DEPARTMENT OF NATURAL RESOURCES

RE: Proposed Changes in Saukville/Freeman Chemical Co. Groundwater Monitoring Program: Installation of Bedrock Piezometers and Replacement of Shallow Piezometers

PROPOSED CHANGES IN GROUND-WATER MONITORING POINTS

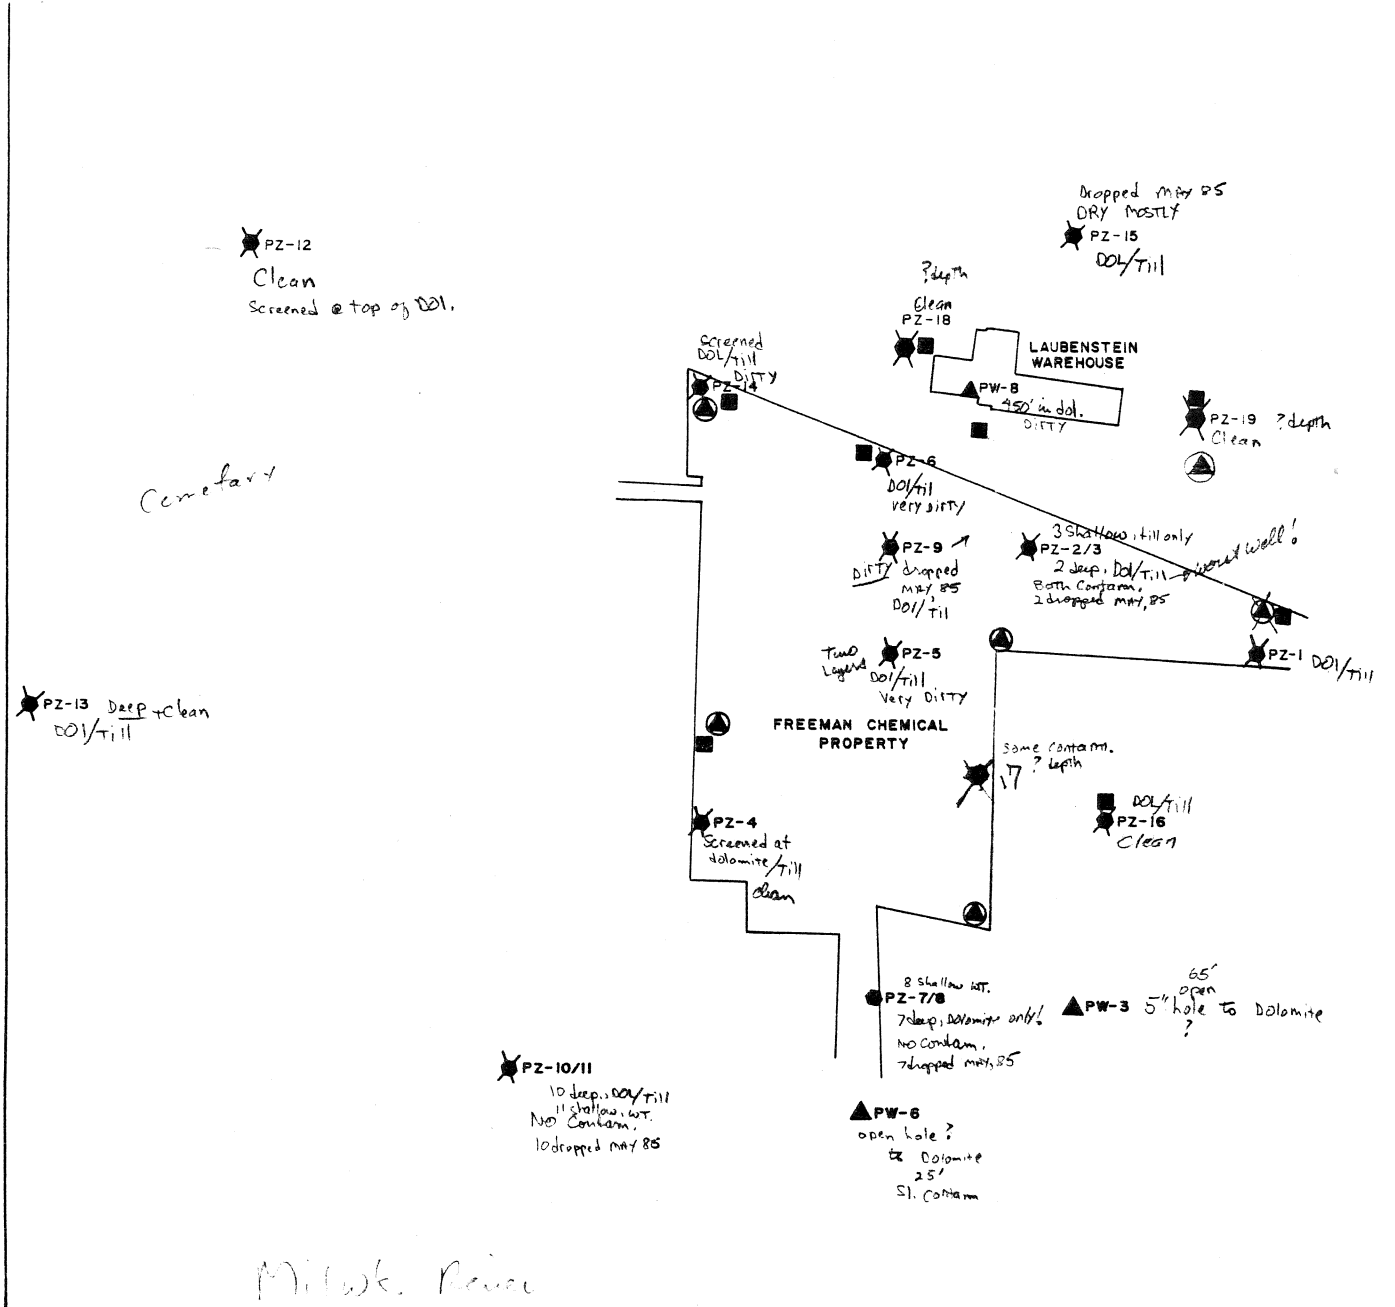
1. Deep piezometers: The Department's main concern has been to determine the extent of contamination of the bedrock aquifer. Towards this end, installation of the four deep piezometers (50-100 feet dolomite) on the Freeman Chemical Company property and two between the Freeman property and the municipal pumping wells is acceptable.
2. Replacement of shallow piezometers: A number of the present piezometers are screened at the dolomite/glacial till interface. As such these wells are neither water table wells nor bedrock wells and do not sample groundwater that is representative of either formation. The Department agrees that the following wells in this category will be abandoned and replaced with properly screened shallow piezometers.

PZ-1, PZ-4, PZ-6, PZ-14, on the Freeman Chemical Company property
PZ-18, PZ-19, on the Oaubinstein property
PZ-16, offsite near the school house

Placing a new shallow piezometer between the Freeman property line and the Laubenstein well (PW-8) is an excellent suggestion.

3. Shallow wells to be abandoned with no replacement: Piezometers 10/11, 12, and 13 south of the Freeman property are also screened at the dolomite/till interface and do not sample groundwater from either geologic formation. In the past these wells have shown no levels of contamination. The Department agrees that these wells can be abandoned.

There are four monitoring wells on the Freeman Chemical Company property that are highly contaminated with organic compounds. These are PZ-2/3, PZ-5, and PZ-9. Piezometer 9 was also found to be contaminated with algal growth, and piezometers 2 and 5 may actually act as conduits for contaminants to the bedrock. These four wells should be properly abandoned.

4. Monitoring wells that will remain: piezometers 7/8 are properly screened and will remain in place. Private wells PW-3 and PW-6 should remain as part of the monitoring program.

Shallow - start screen a few feet below surface make it 5-10 ft. so that shallow till will intersect.

The old well should be abandoned by overdrilling to remove the packing and the well filled with bentonite using a tremie tube. DNR guidelines for proper abandonment are found in the enclosed DNR "Guidelines for Monitoring Well Installation."
